Additional Information
Planning Ref: SD22A/0372
February 2023

Reg. Ref. SD22A/0372

Saint Claires Villa, Lucan Road, Lucan, Co. Dublin, K78 X0N1.

Proposed Development at St. Claire's Villa, Lucan, South County Dublin.
Additional Information Response Landscape Cover Letter

Figure 1. Pre-cast concrete unit paving, laid with proprietary spacers. Figure 2. 'Nidagravel' grid filled with angular gravel

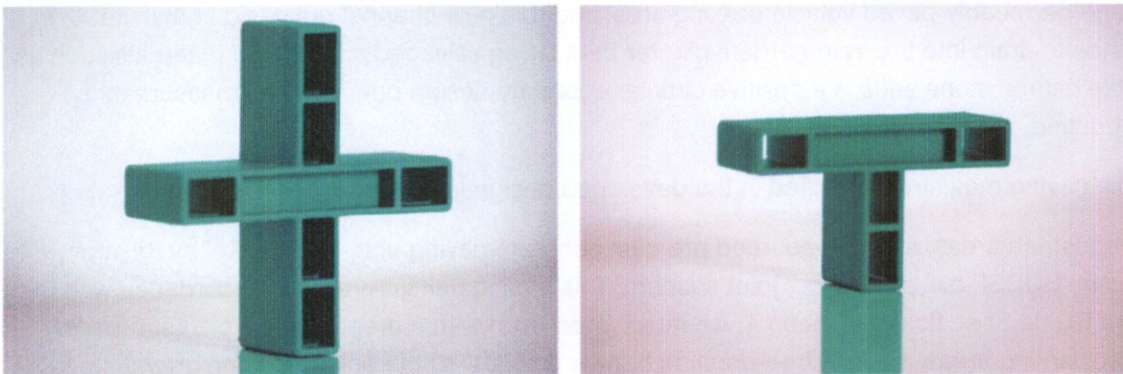
- To pedestrian areas: a locally-sourced pre-cast concrete paving unit, 'Pembroke' by Kilsaran, laid with 'SUDSFlow' proprietary joint spacers. This paving unit is A-rated in accordance with the Green Guide Specification Edition 4, A+ rated when used with a prepared recycled sub-base.

- To car-parking areas: a 100% free-draining honeycomb UV-stable polypropylene gravel stabilisation grid; this grid to contain at least 30% recycled plastic content, to retain locally-sourced angular gravel aggregates, 6-10mm single size e.g., 'Ballylusk'. This paving build-up must be suitable to be trafficked with wheelchairs, mobility devices and buggies.
